PRODUCER STATEMENT – PS4 – CONSTRUCTION REVIEW

IN RESPECT OF: Seismic Strengthening
(Description of Building Work)

AT: 34 Upland Road, Kelburn
(Address)

Project Address:	34 Upland Road, Kelburn	Document Name:	223303-SN-002-A
Client:	Wallcork Upland Ltd	Building Consent:	549500
Engager:	Wallcork Upland Ltd	Builder:	Strait Construction

Figure 3.

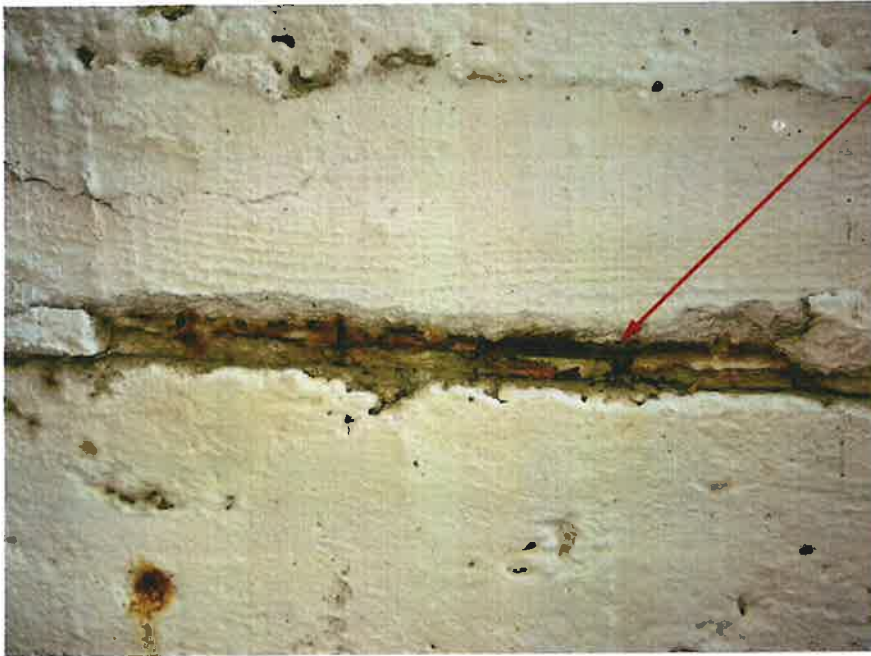
Example crack with corroded reinforcing where the reinforcing needs to be exposed, treated/replaced and the concrete repaired.

Figure 2.

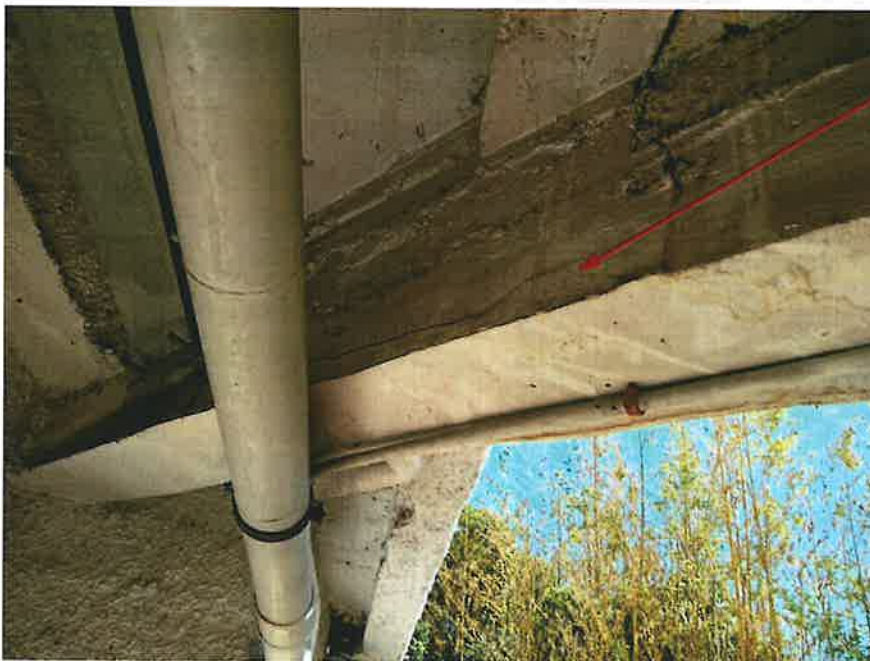
Example crack where the reinforcing needs to be exposed, treated and the concrete repaired.

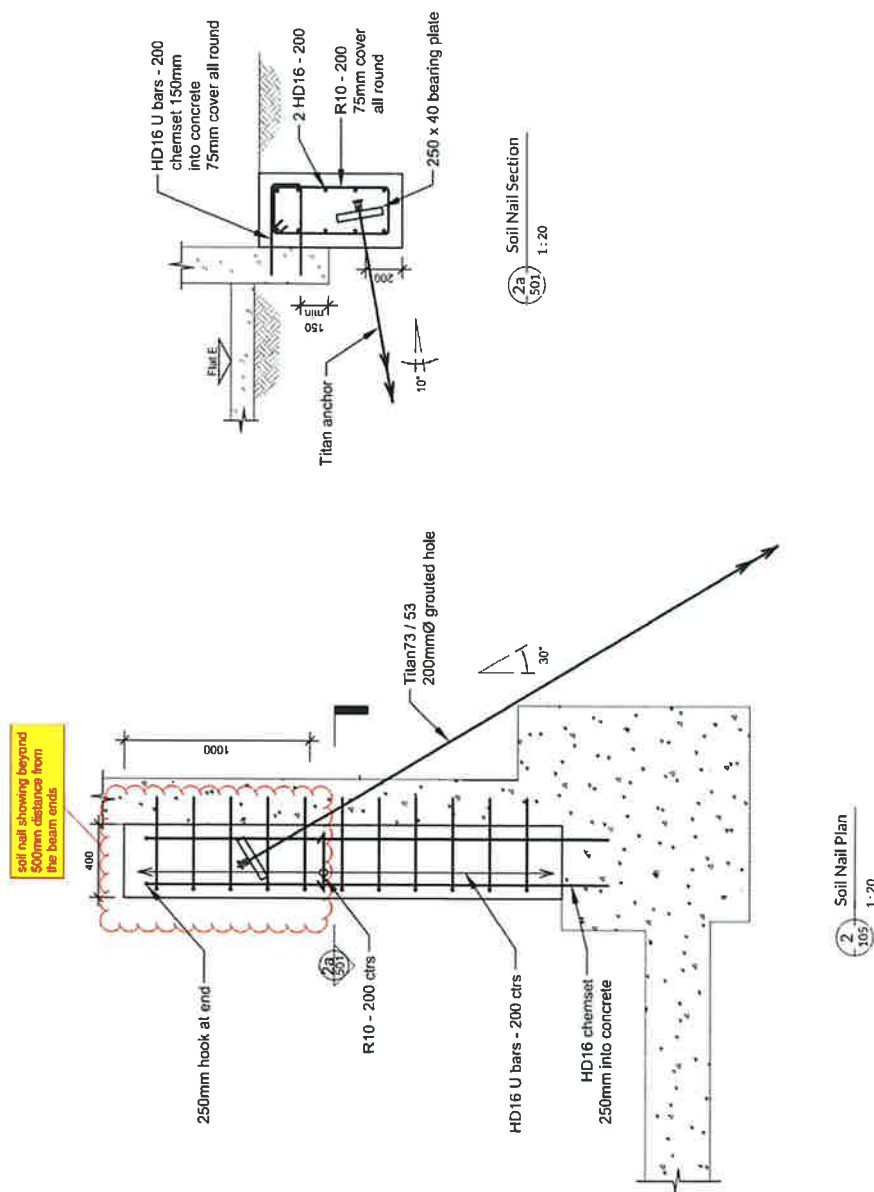
Pile reinforcement and HD12 bars epoxied into the existing concrete,

Shift the anchor plate to be vertically centred in the cage.

Only ten (10) legs of R12 stirrups are present. The required number of legs is sixteen (16).

Install additional three (3) sets of R12 near the anchor

Only ten (10) legs of R12 stirrups are present. The required number of legs is sixteen (16).

Install additional two (2) sets of R12 near the anchor

Install a set of R12 stirrups

1. Proceed with the Grid A garage ground beam without piles.
2. Ok to pour concrete for the grid H ground beam.
3. Grid D ground beam:
 - Shift the vertical anchor plates to be vertically centred in the cage.
 - Add additional stirrups around the vertical anchors.
 - Install the concrete wall starter bars.
4. DTCE will return to site to review the reinforcing pre-pour for Grid A garage beam and Grid D concrete beam with vertical soil anchors.
5. Anchor drill logs to be provided to DTCE.

Figure 7. Garage foundation at grid A

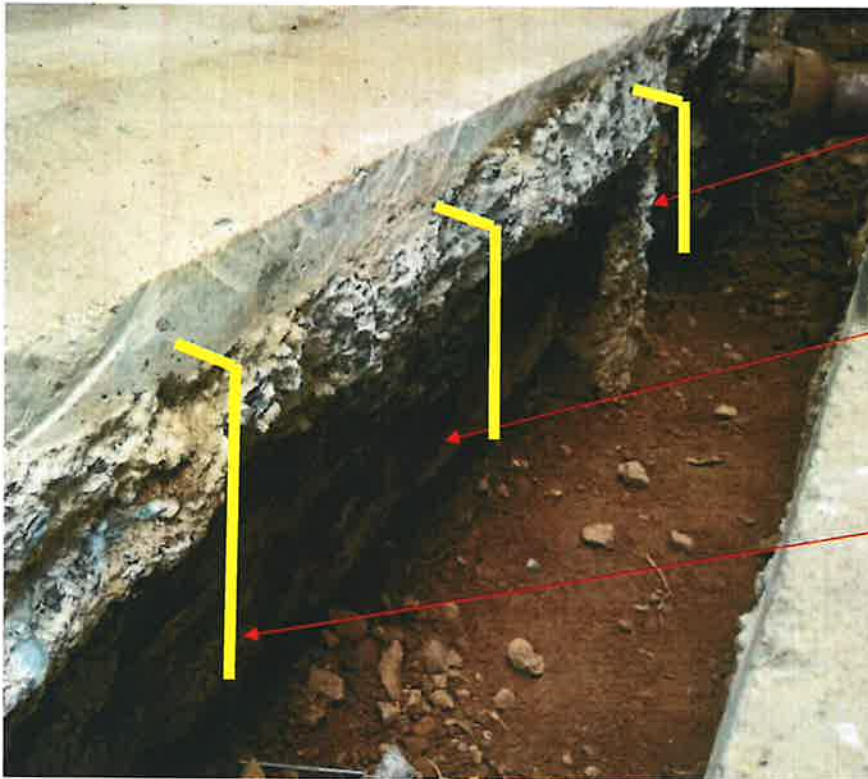
Buttress found after excavation

Existing retaining wall found after excavation

Install HD12 starter L-bars, 400 centres, epoxy 200mm into existing slab and retaining wall/buttress at ends.
